**VALUE ENGINEERING SUMMARY
OF
US 119/BENT MT. TO COBURN MT.
WPI NO. 12-264.01
PIKE COUNTY, KENTUCKY**

DECEMBER 5-13, 1996

**Prepared by:
Ventry Engineering**

**Kentucky Transportation Cabinet,
Department of Highways**

VALUE ENGINEERING
 ALTERNATIVE

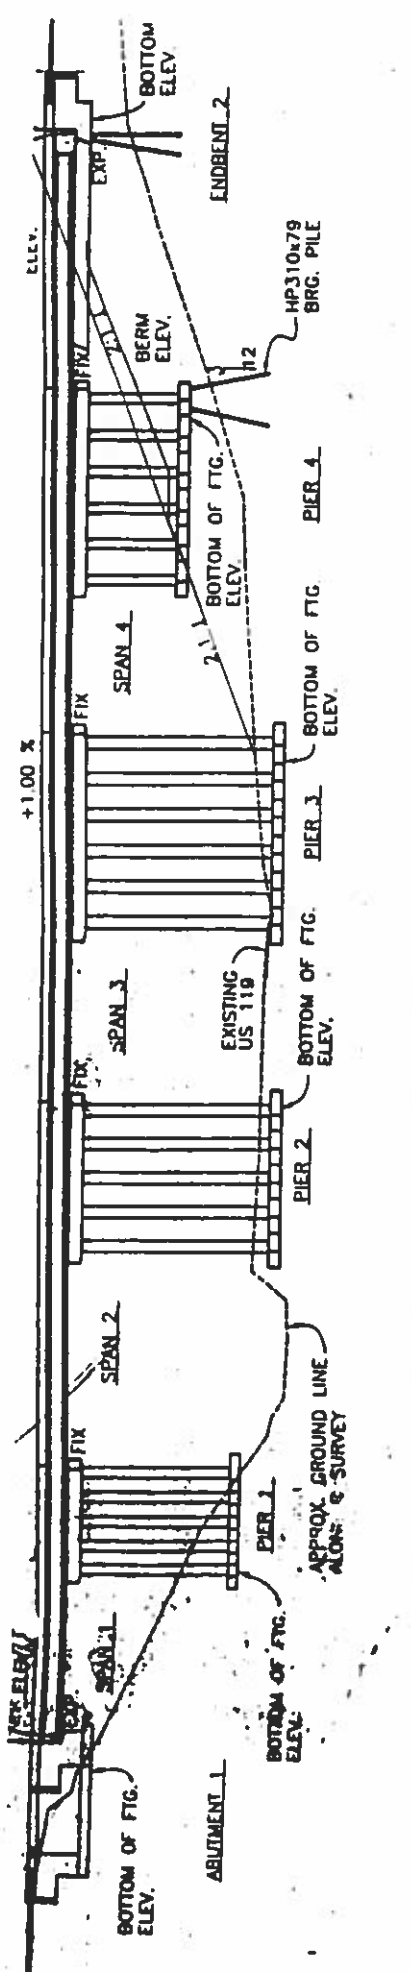
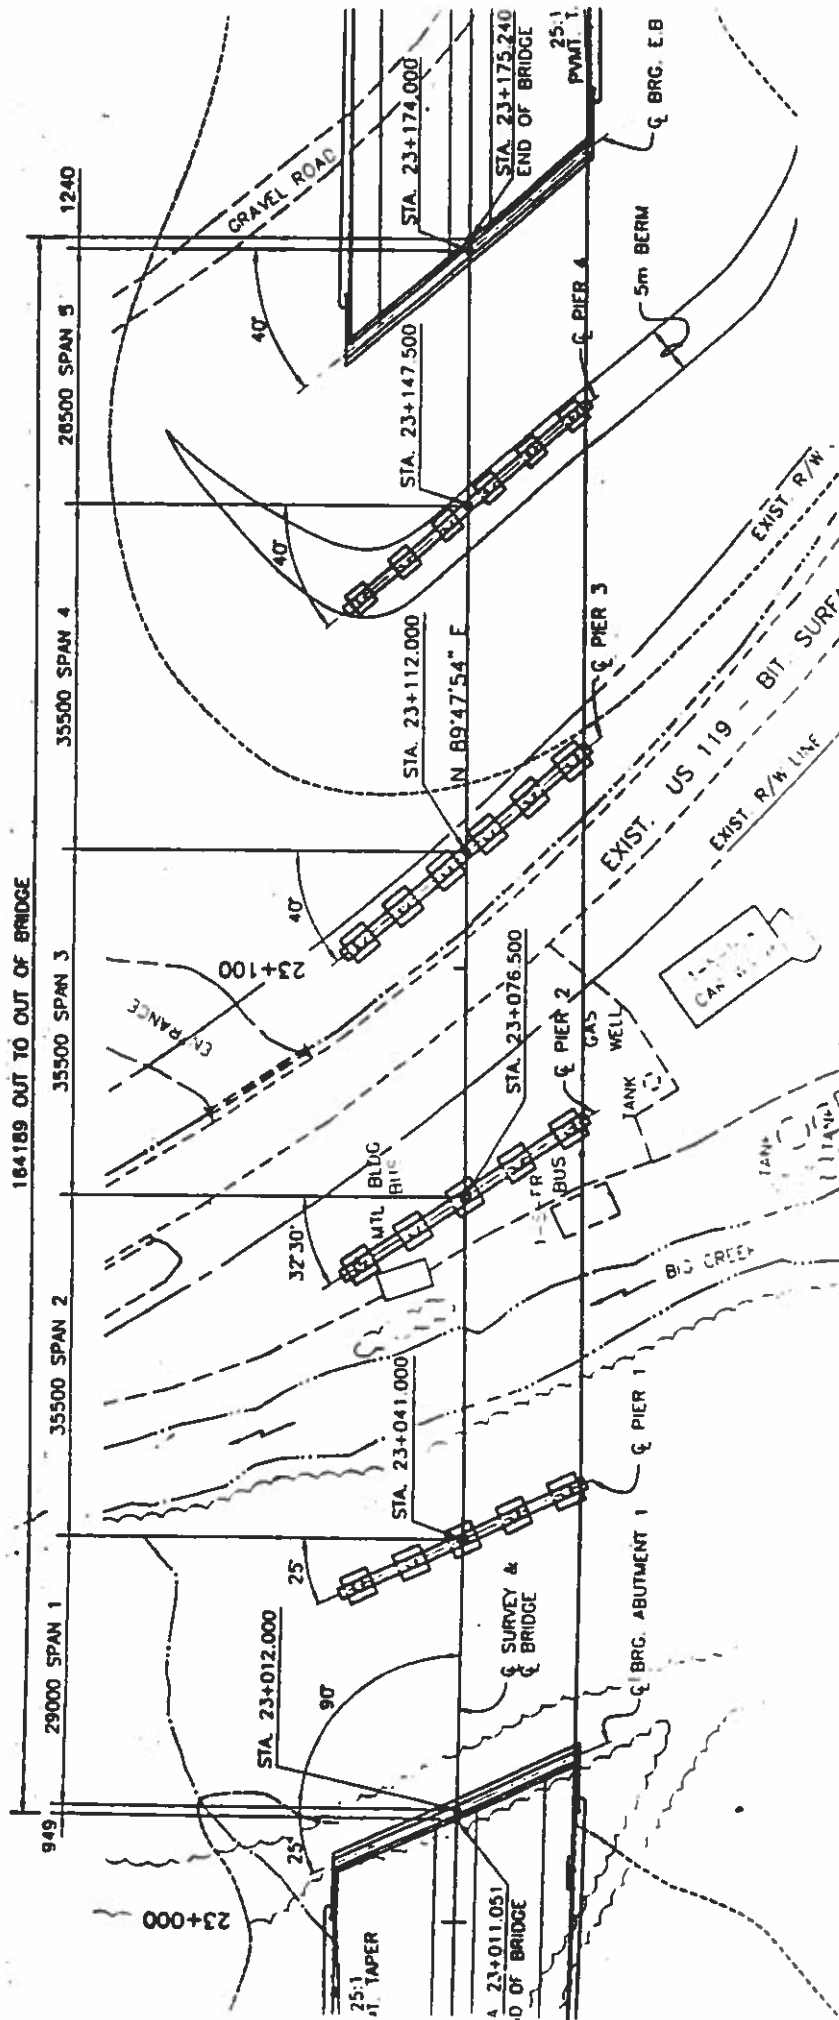
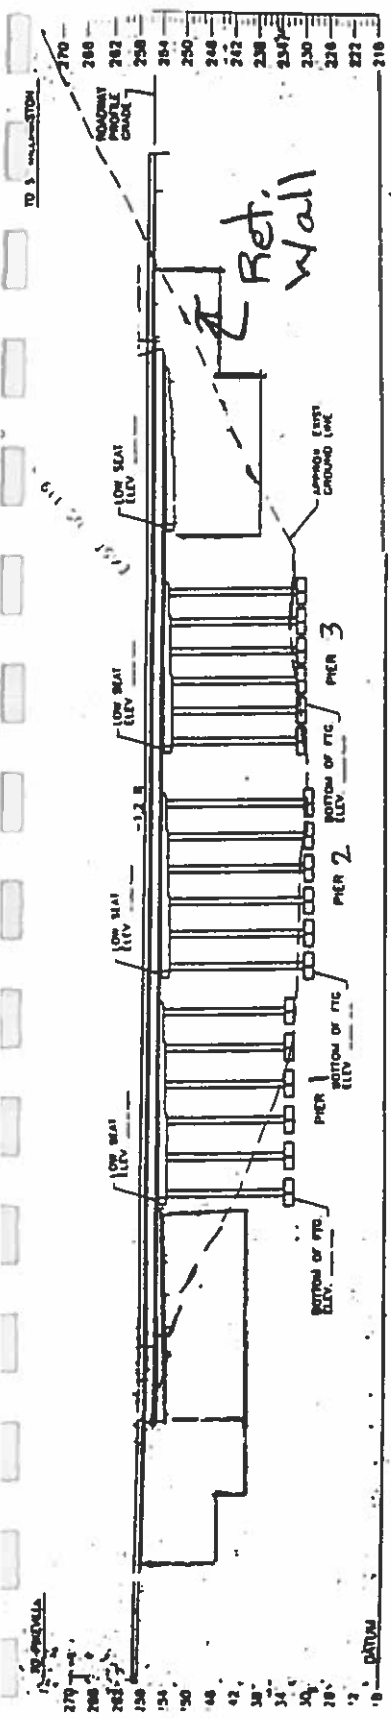
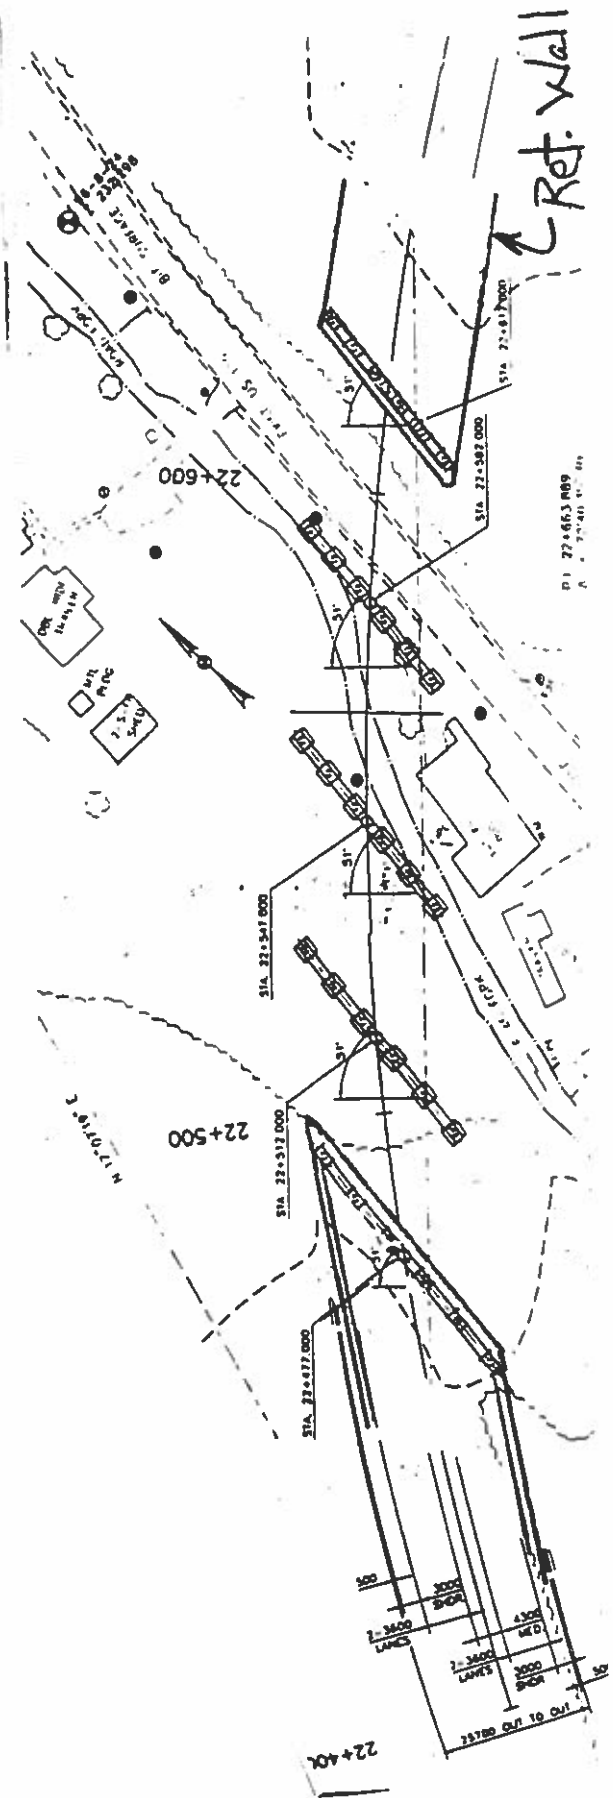
The first structure at Sta. 22 + 550 is a six span (24000 X 4 spans @ 35000 X 29000) structure utilizing 72" modified Type IV P.C.I. beams. The bridge spans Road Ford and existing U.S. 119. The bridge is on a 51° skew to the right. It is anticipated that all the piers will utilize spread footers on rock and the foundation design for the abutments will be determined after the subsurface data has been gathered. The anticipated cost of this structure is \$3,551,194.00.

The second structure at Sta. 23 + 100 is a five span (29000 - 3 spans @ 35500 - 26500) structure utilizing 72" modified Type IV P.C.I. beams. This structure spans Big Creek and existing U.S. 119, with a skew which varies from 25° to 40° left. While the subsurface information is not yet complete, it is anticipated that the foundations for piers 1 thru 3 will be spread footers on rock and pier 4 will be on H-Piles on point bearing, as well as end bent two. It is anticipated that the beginning of the bridge will be an abutment on rock. The anticipated cost of this structure is \$2,974,000.00.

The V.E. alternative for Bridge 1 (at Sta. 22 + 550) is to use a four span bridge (4 @ 35m) and retaining walls at the abutments. This structure will be shorter than the "As Proposed".

This alternative will cost approximately \$3,211,500.

Possible Savings \$ 254,749

VE Alternate
3 Span Bridge

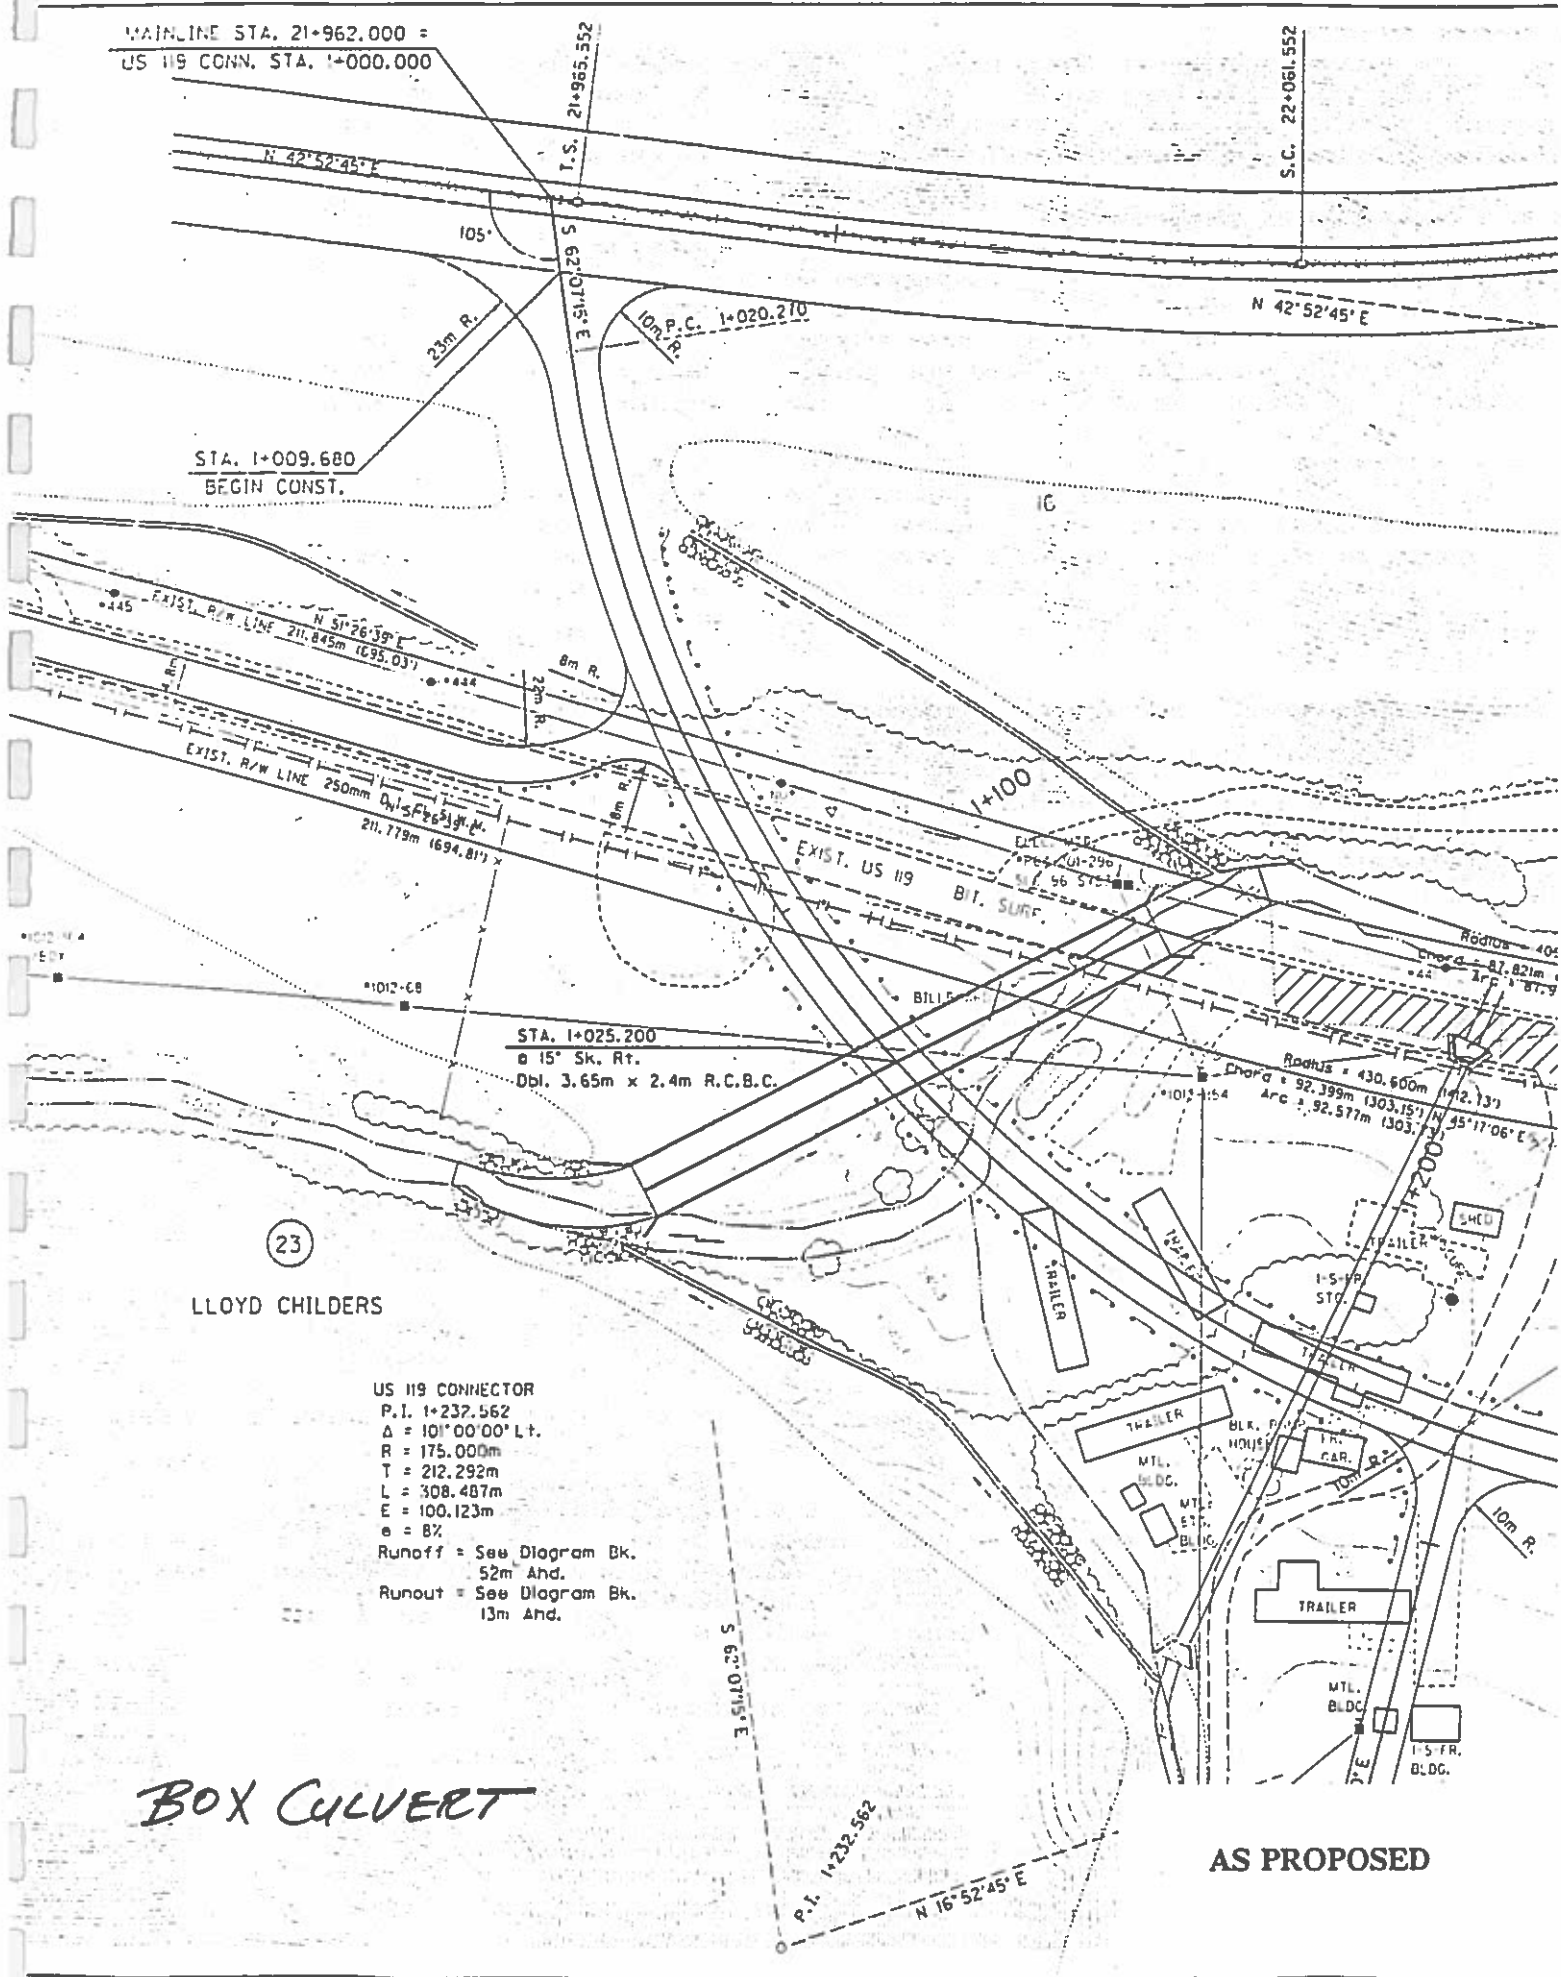
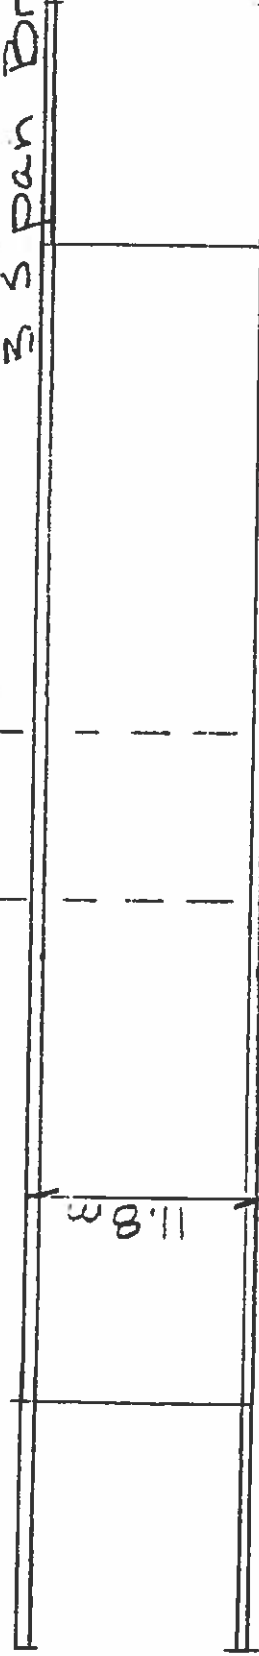
The Value Engineering alternative is to replace the R.C.B.C. with a three span concrete bridge. The length of the bridge would be 72.5 meters and the cost would be \$612,538.

AS
Proposed
Dbl. 3.65 x 2.4 RCBC
77 m long

V.E. Alternative

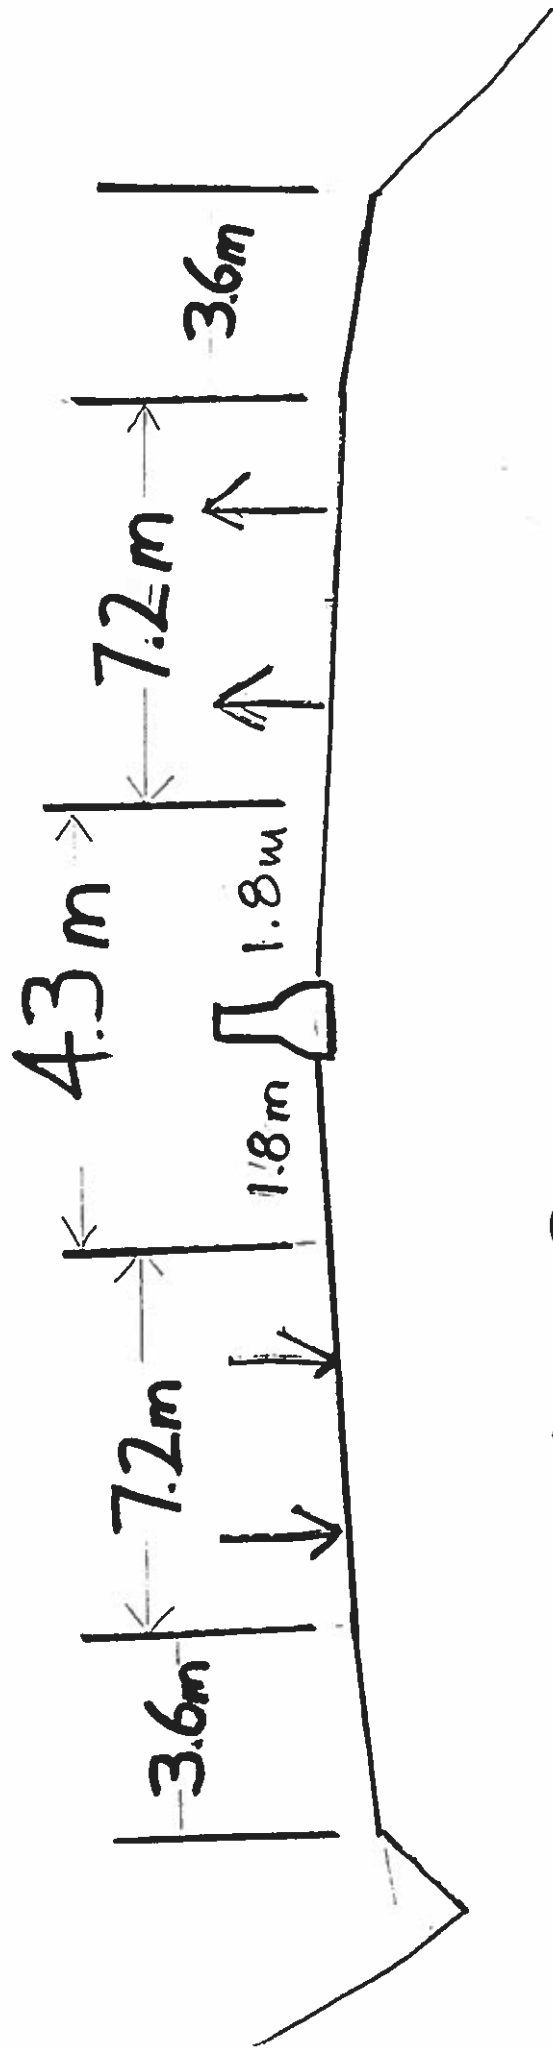
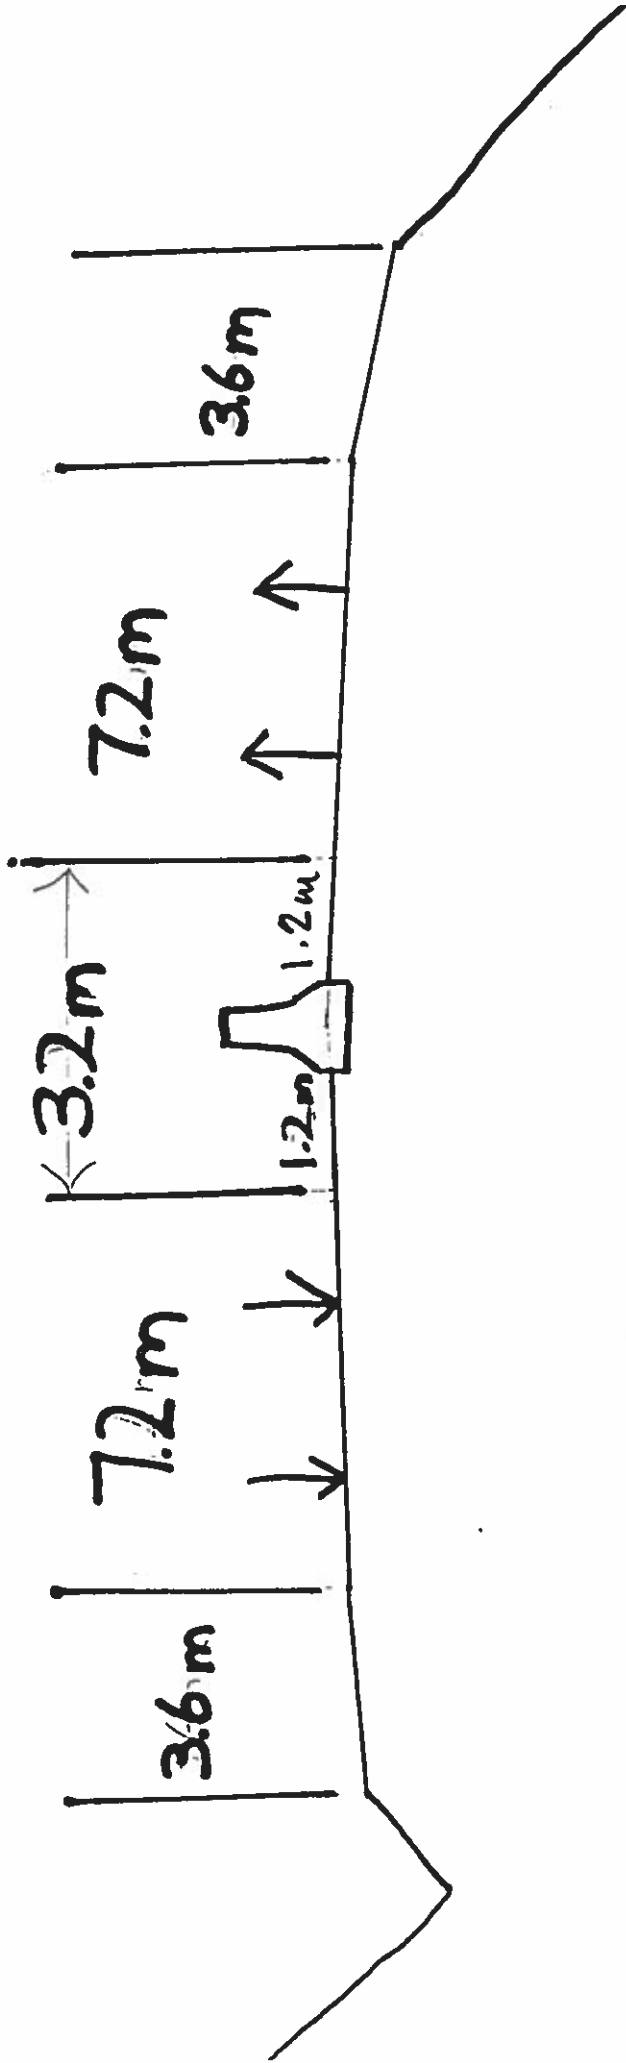
The mainline typical as depicted in the construction plans has a 4.3m (14 feet) flush median with a median barrier wall in most of the project. The project to the south of this one has a 10.5 ft (3.18 meter) median with a median barrier wall. This 4.3 meter typical section facilitates the development of a left turn lane in the median in the areas where access is being provided. The current plans indicate the following barrier wall requirements for this project from Road Fork to 1.9 kilometer east of KY 3154:

The V.E. team recognized the difference in typical sections of the adjoining project on the west end and this project during the field review of this Pike County project. After review of the as-built plans the team decided to pursue the reduction of earthwork this change would create.

Possible Savings \$800,748
